Part 1. Refinery Feedstock Switch

CBE Comments on Chevron 1/25/08 FEIR

Figure 2. Blends of crude oils identified by the FEIR v. Project design crude slate sulfur.

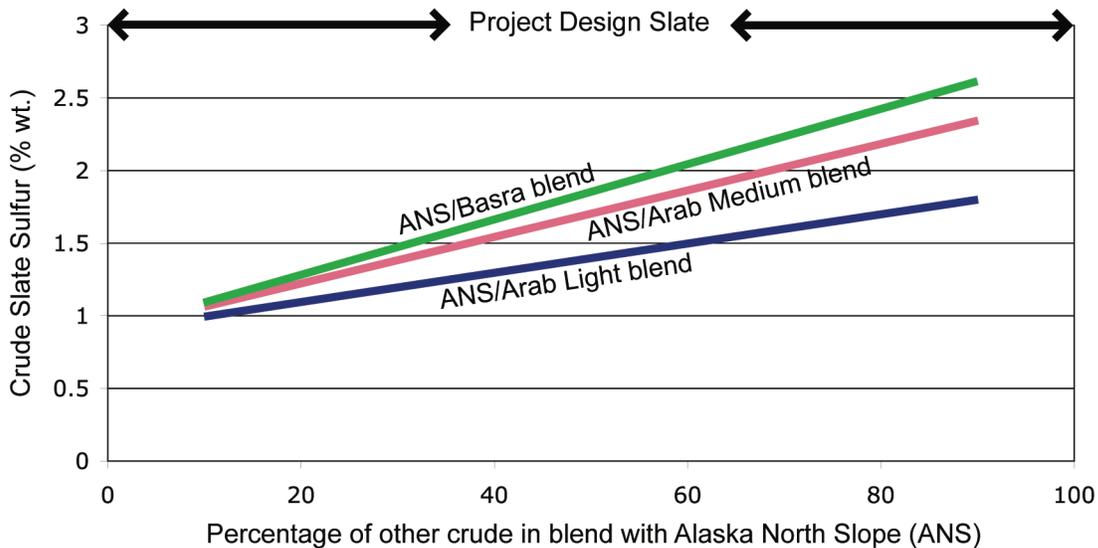
The Project is designed to run a lower quality crude slate than the FEIR identifies.¹² Based on its 3% sulfur design, for example, the Project would enable a higher sulfur slate than any blend of ANS with Basra, Arab Light, or Arab Medium, and would allow the Refinery to run 100% Iraqi Basra crude. See Figure 2.

Figure 3. Refinery heavy gas oil and residuum process flow diagram.

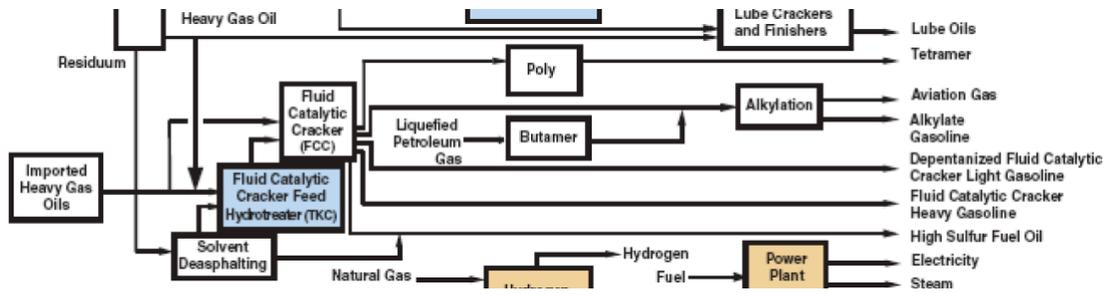
As shown in Figure 3, the Fluid Catalytic Cracker (FCC) would be fed oil produced from residuum and heavy gas oils by the Solvent Deasphalting and TKC units, in addition to a direct feed of imported heavy gas oil.³³ The FEIR admits that average TKC throughput could increase to 80,000 BPD but insists this will not increase FCC throughput because the FCC's annual permit limit is already 80,000 BPD.³⁴ The FEIR is in error. Actual long-term average FCC throughput is approximately 63,900 BPD, as shown in Table 3. Receiving 80,000 BPD from the TKC would increase this FCC throughput by 16,100 BPD or 25%. The direct feed of imported heavy gas oil to the FCC shown in Figure 3 would further increase FCC throughput.

Solvent Deasphalting (SDA) could increase heavy feedstock processing by 25,360 BPD or 62% (Table 3; Figure 3), but this is not disclosed or analyzed in the FEIR at all.

Figure 5. Comparative scale of proposed feedstock sulfur increase.

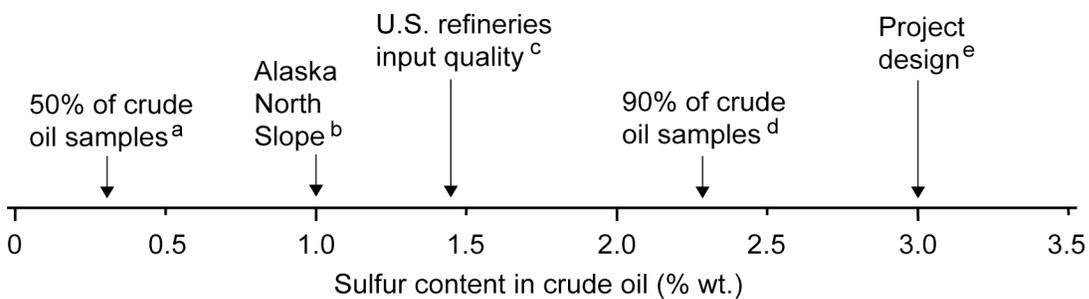
Further, the FEIR's description of a "similar" crude slate with 1% more sulfur does not describe the extent of this feedstock quality switch. The post-Project slate could have twice as much sulfur as the U.S. refinery input, three times as much as the Refinery's previous ANS-dominated slate, ten times as much as 50% of the crude samples from available assays, and more sulfur than 90% of these 9,390 crude samples. See Figure 5.

This extreme contamination of the proposed feedstock is not disclosed in the FEIR.
